Product Change Notification

Bourns® Model SM-LP-5001 and SM-LP-5002 Series Surface Mount Line Matching Transformers Change to Carrier Tape Specifications

Existing Tape Carrier Dimensions

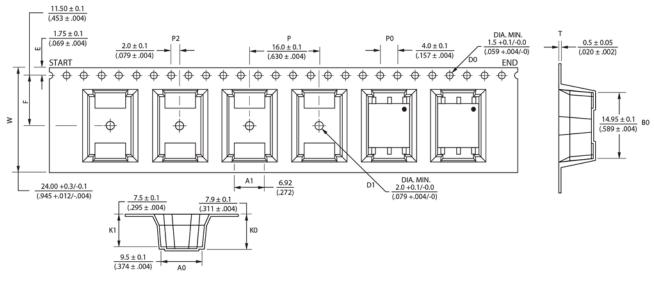
Bourns has decided to change the carrier tape specifications for the Model SM-LP-5001 and SM-LP-5002 Series Surface Mount Line Matching Transformers. The carrier tape has been redesigned to help limit lateral movement of the component to within 1 mm in compliance with the EIA-481-D Standard. The form, fit and function of the transformer will remain the same. Specifications of the carrier tape are provided on the following page.

ITEM	W	A0	ВО	КО	Р	F	E	D0	D1	P0	P2	Т	A1	K 1
DIM	24.00 ^{+0.30} _{-0.10}	9.50 ^{+0.10} _{-0.10}	14.95 ^{+0.10}	7.90 ^{+0.10}	16.00 ^{+0.10}	11.50 ^{+0.10}	1.75 +0.10	1.50 +0.10	2.00 +0.10	4.00 +0.10	2.00 +0.10	0.50 +0.05	6.92 +0.10	7.50 ^{+0.10}
